Grandview Reserve FINAL DRAINAGE REPORT

April 19, 2024

PCD File No. CDR228

Revise the Title. This project (CDR228) is for the Gieck Ranch Main Stem Tributary 1 & 2 design and construction only.

EXISTING FLOODPLAIN EXHIBIT

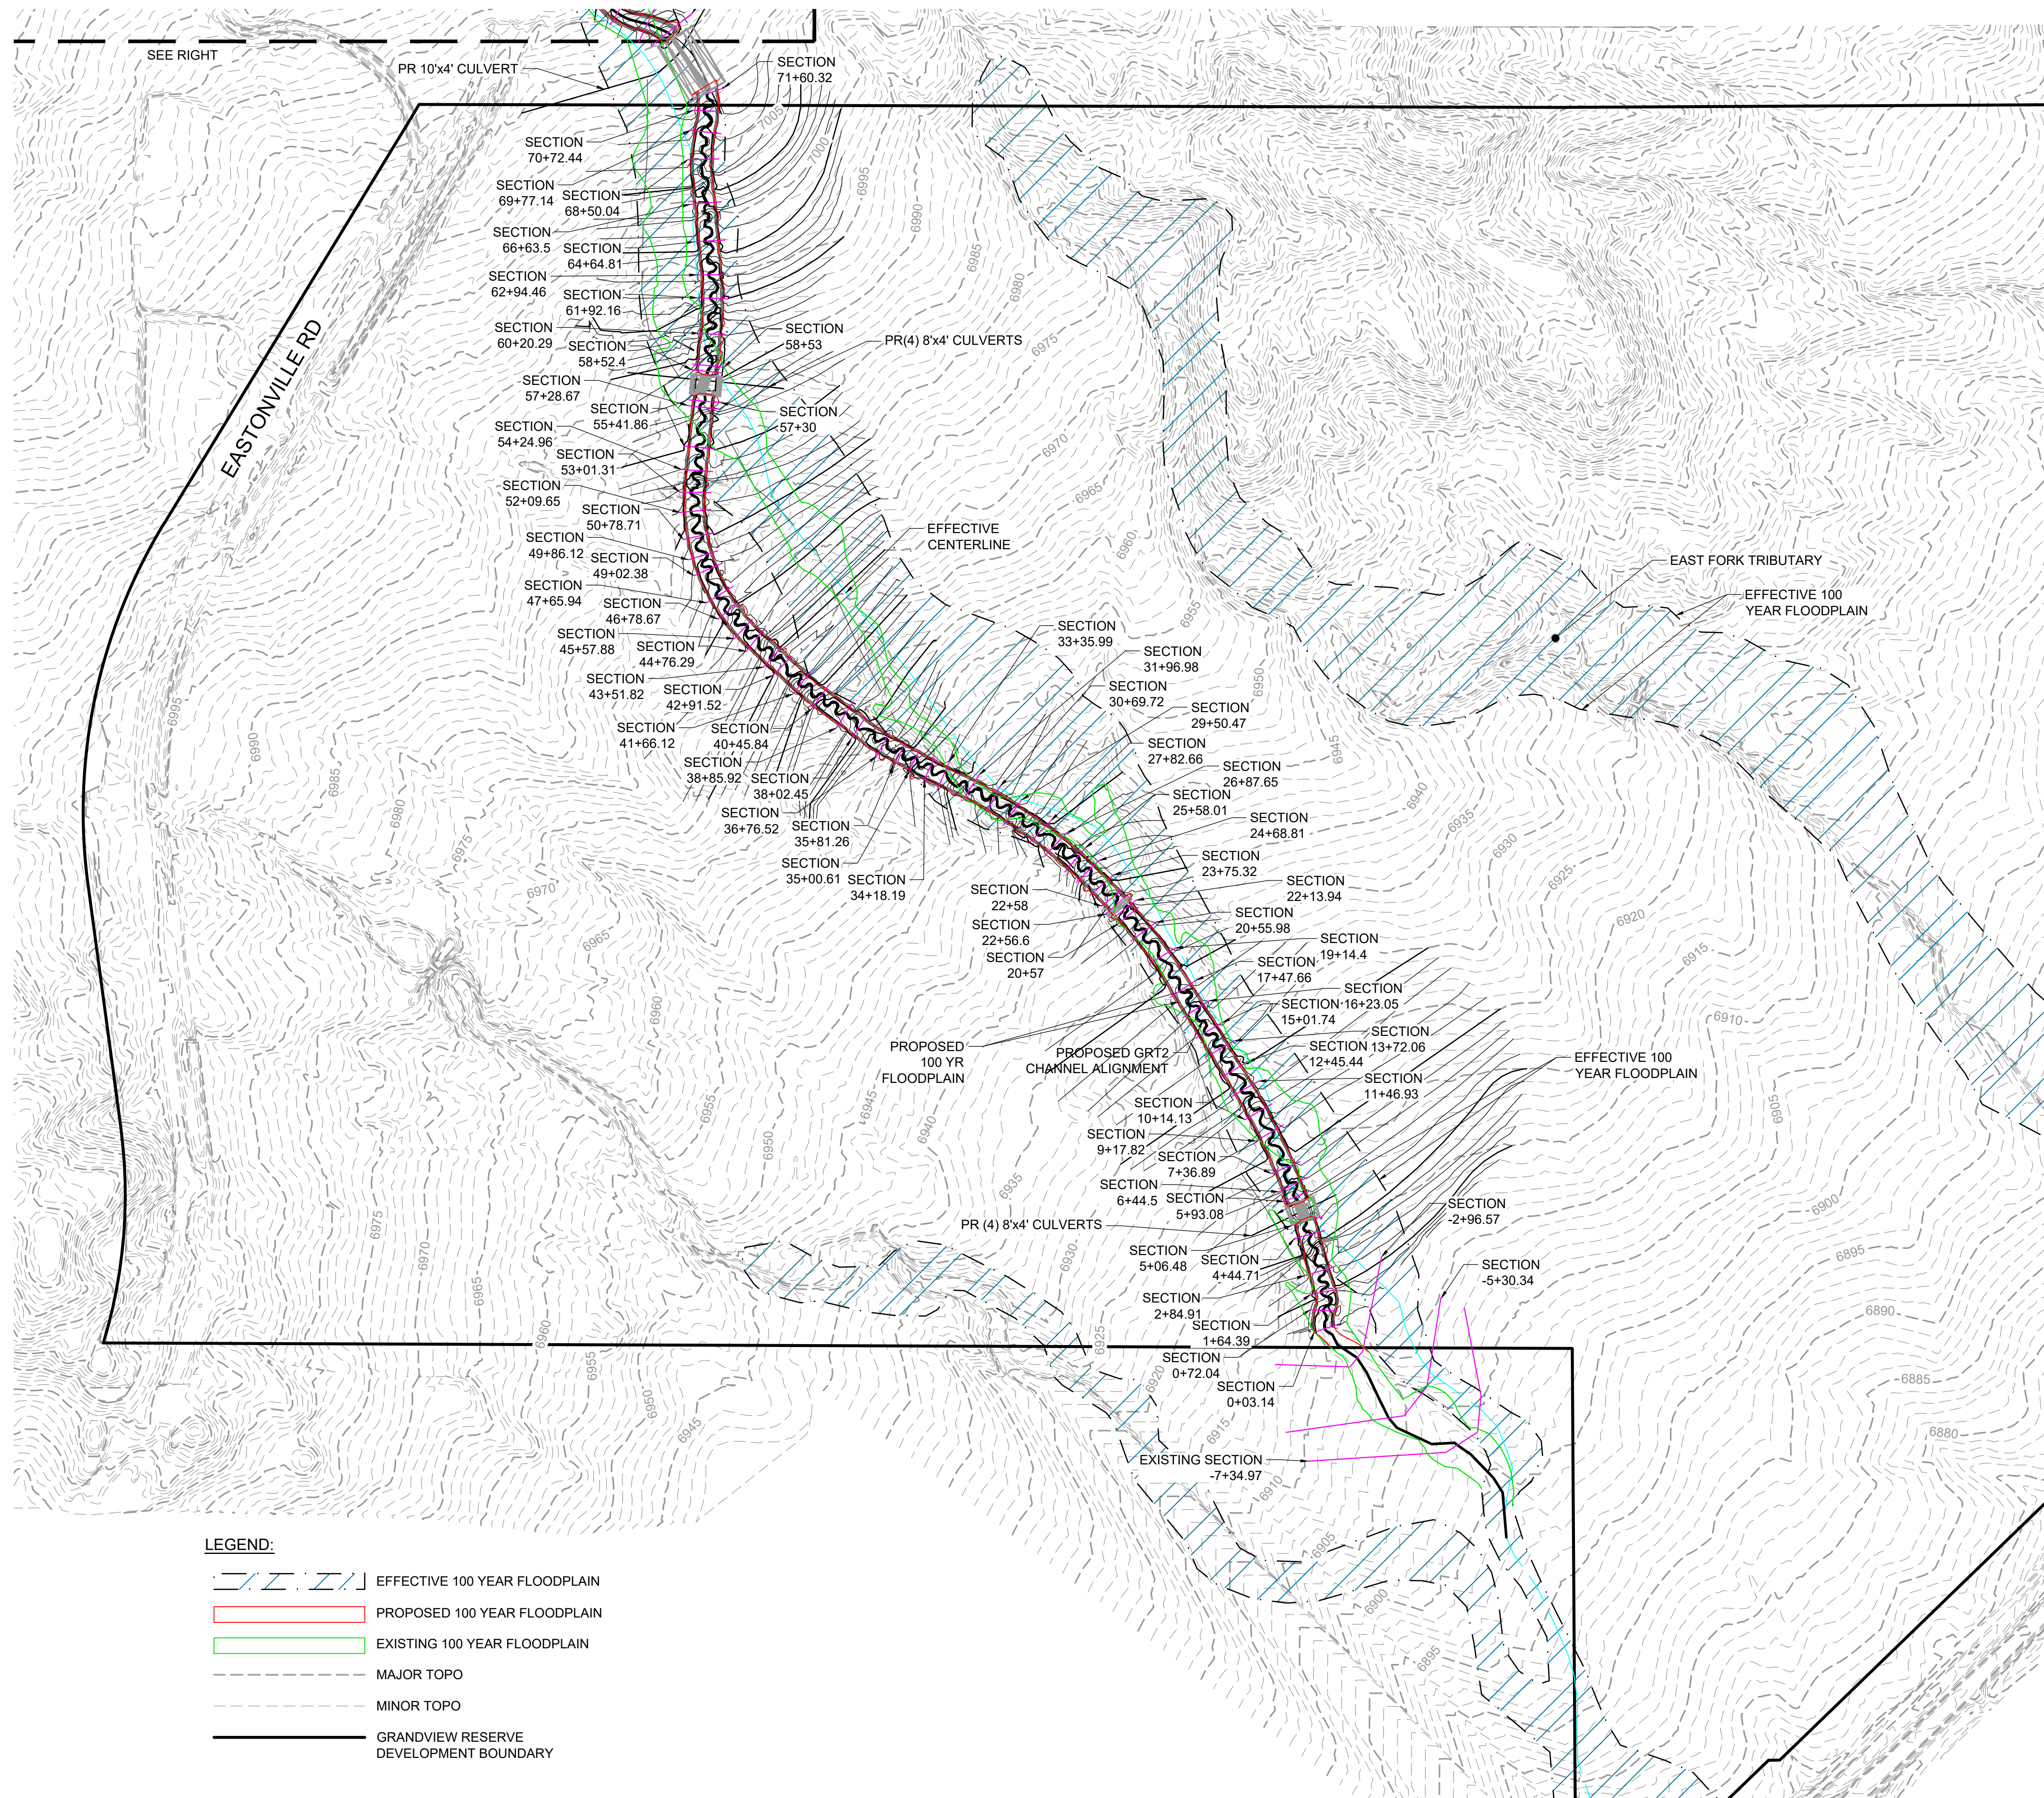
Provide profile &
output table
